CLERK'S CONTRACT and AGREEMENT COVER PAGE

Contract Description: Design-Build John Humphrey Complex Renovation (+ \$160,838 contingency)
C19-0080 Addendum A Peat Mitigation & 4" path (2019-0375 \$547,666 + \$109,400 contingency)
C19-0141 Addendum B Additional Work (2019-0647 \$262,324)

ADDENDUM B to
John Humphrey Complex Renovations

Change Order Proposal #2

Option 2.1 - Concession Building
Concrete

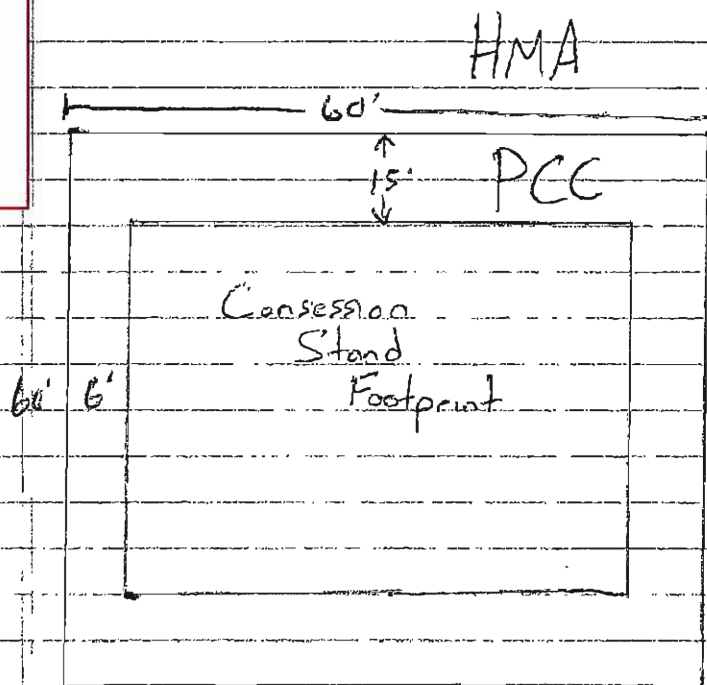
Concrete being removed and replaced
around the concession stand in it's
entirety

1.0 This change order proposal is to remove & replace the PCC flatwork around the existing concession building. See attached sketch for limits of R&R.

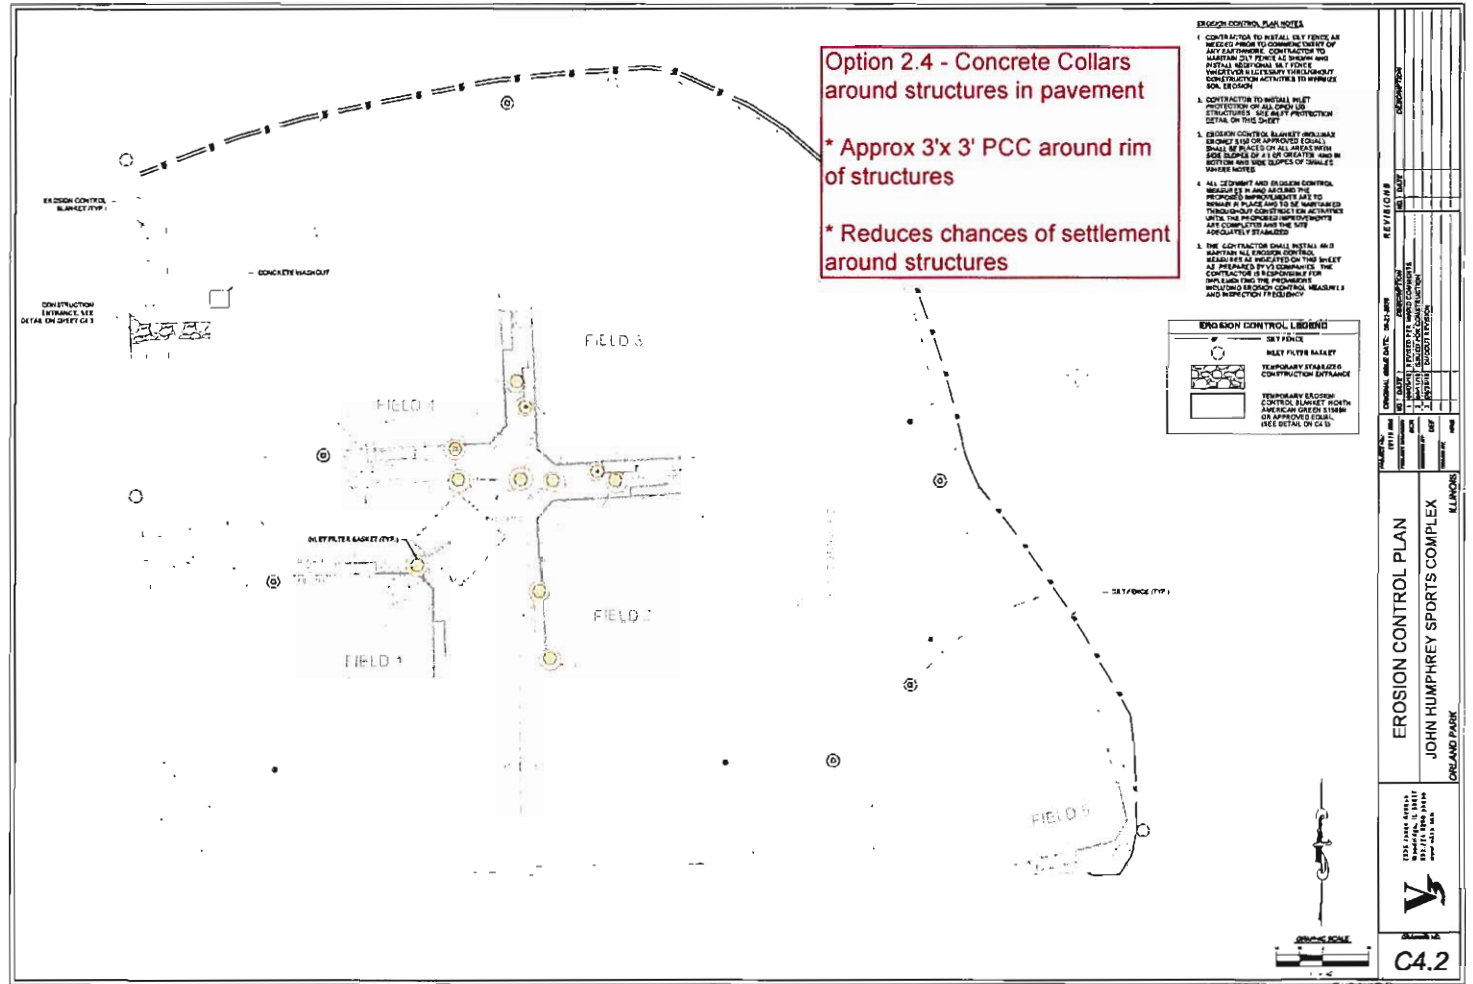
515 If various heights barrier curb w/out footing as shown (max height 2'4" total per grading plan) \$ 25,750.00
Quantity per V3 extended curb exhibit

Option 2.6 - Outfall Pipe Revision

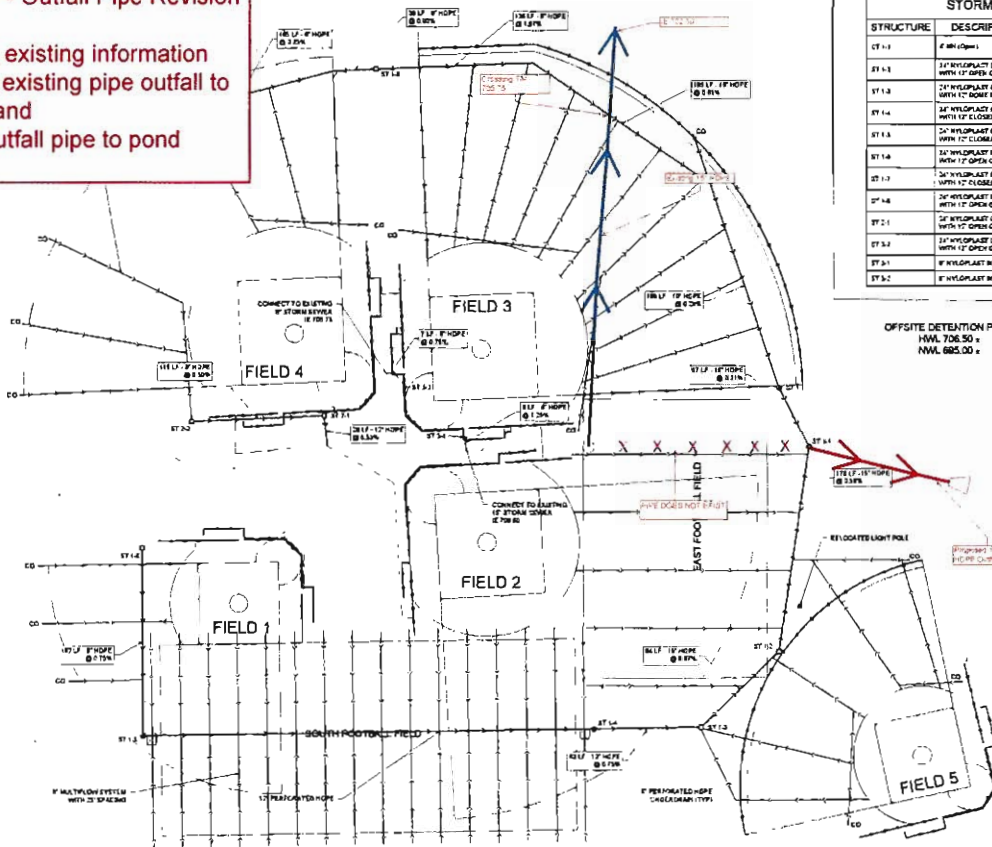
- * Incorrect existing information
- * Updated existing pipe outfall to north wetland
- * Added outfall pipe to pond
